## CITY OF NORMAN, OK HISTORIC DISTRICT COMMISSION MEETING

Development Center, Room A, 225 N. Webster Ave., Norman, OK 73069 Monday, March 03, 2025 at 5:30 PM

### CITY OF NORMAN, OK STAFF REPORT

ITEM TITLE: (HD 24-04) CONSIDERATION OF APPROVAL, REJECTION, AMENDMENT, AND/OR POSTPONEMENT OF THE CERTIFICATE OF APPROPRIATENESS REQUEST FOR THE PROPERTY LOCATED AT 1320 OKLAHOMA AVENUE FOR THE FOLLOWING MODIFICATIONS: A) CONSTRUCTION OF A NEW HOUSE WITH AN ATTACHED GARAGE; B) CONSTRUCTION OF A DETACHED ACCESSORY DWELLING UNIT; C) CONSTRUCTION OF A CONCRETE PATIO WITH A COVERED PERGOLA. (POSTPONED FROM THE FEBUARY 3, 2025 MEETING)

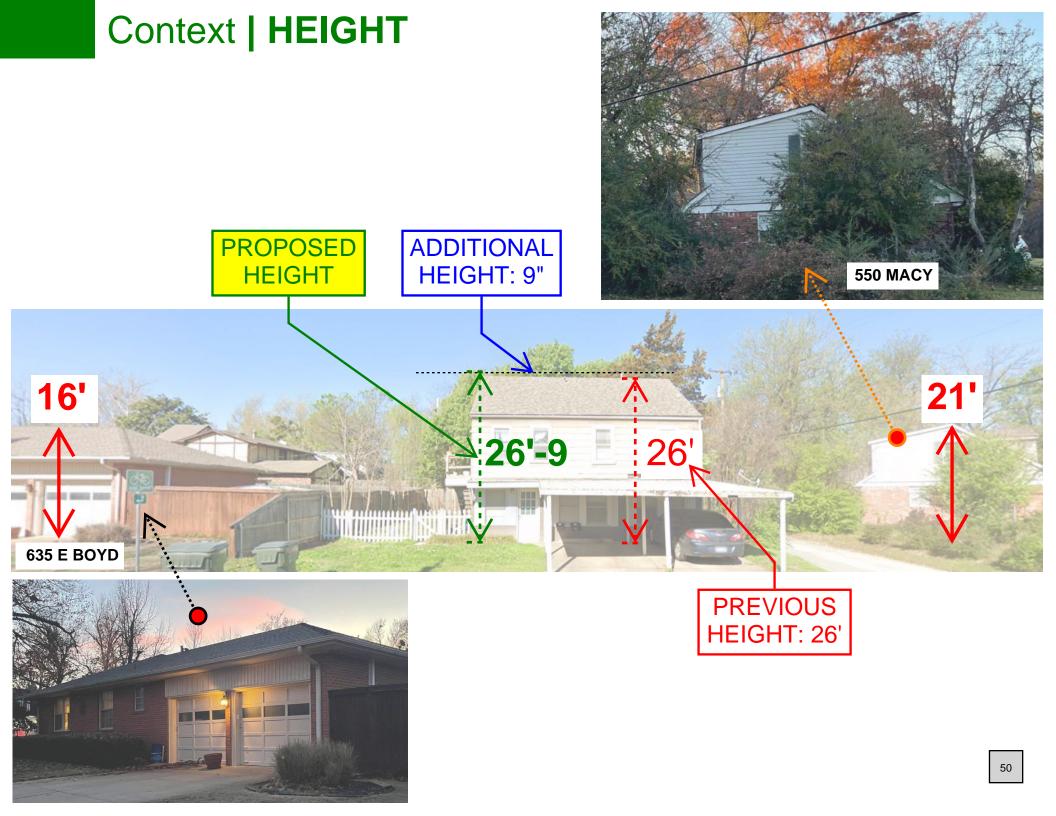
- The current design is too tall.
- Add more overall detail to enhance depth and character.
- Remove stucco from the material palette and update entryway design.
- Reduce vertical emphasis for better proportion.
- The design leans too modern incorporate more traditional elements.
- The proposed 1'-6" finished floor (F.F.) height increases the overall elevation too much.
- Ensure historical references feel authentic; avoid creating a false sense of history.
- The proposed carriage-style garage door does not complement the overall design.

- + Reduced height from 30' to 26'-9"
- + **Added** architectural details, including trim around windows, floor separations, decorative corbels, exterior

+Replaced stucco with a warm wood entry feature entryway with rectilinear pediment.

+ Limited vertical siding to areas just below the gable roof, removing it from ground to roof.

+ **Updated design** to incorporate Colonial inspired architectural elements.

## Context | ELEVATIONS

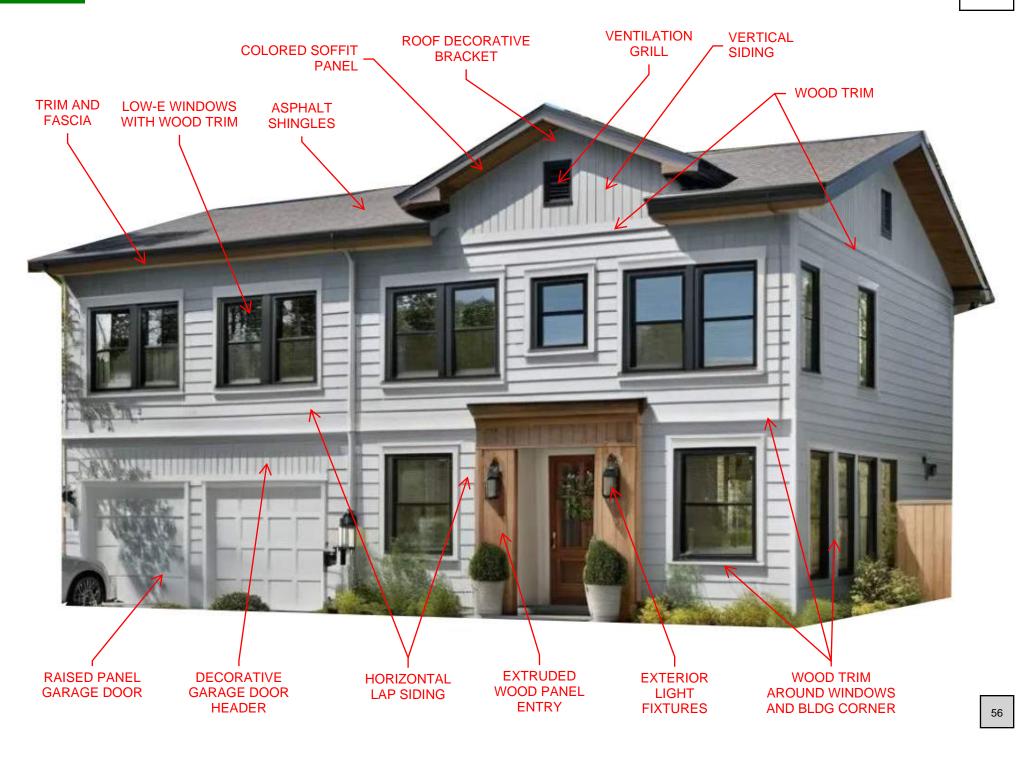
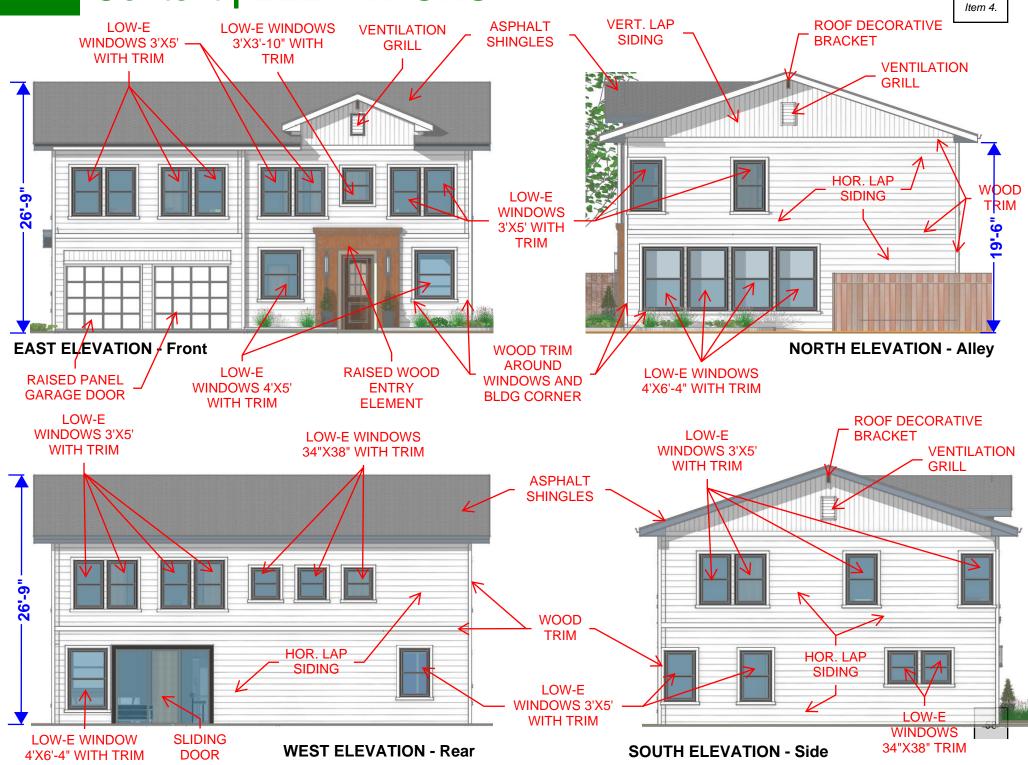
As noted earlier in the staff report, the applicant revised the exterior materials. In addition to providing more details of the exterior, the proposed vertical siding on the exterior wall has been replaced with horizontal siding. There remains limited vertical siding in the gables on the second floor of the house, as well as vertical trim above the garage door.

#### Context | FINISH FLOOR

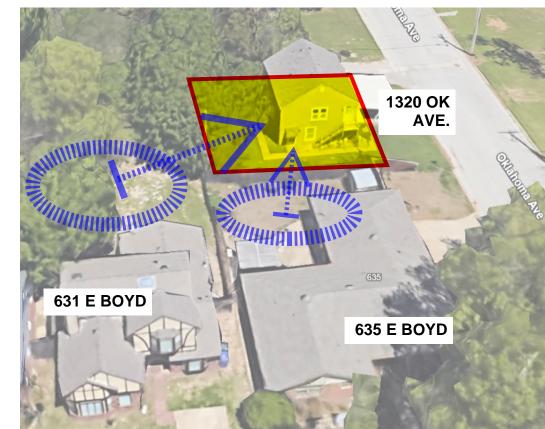
The current site's finished floor is below the adjacent west and south properties, causing water to flow into it, which was the main reason the previous 1st floor base plate was rotten

Request to raise the current F.F. by 6" to prevent water infiltration into house.
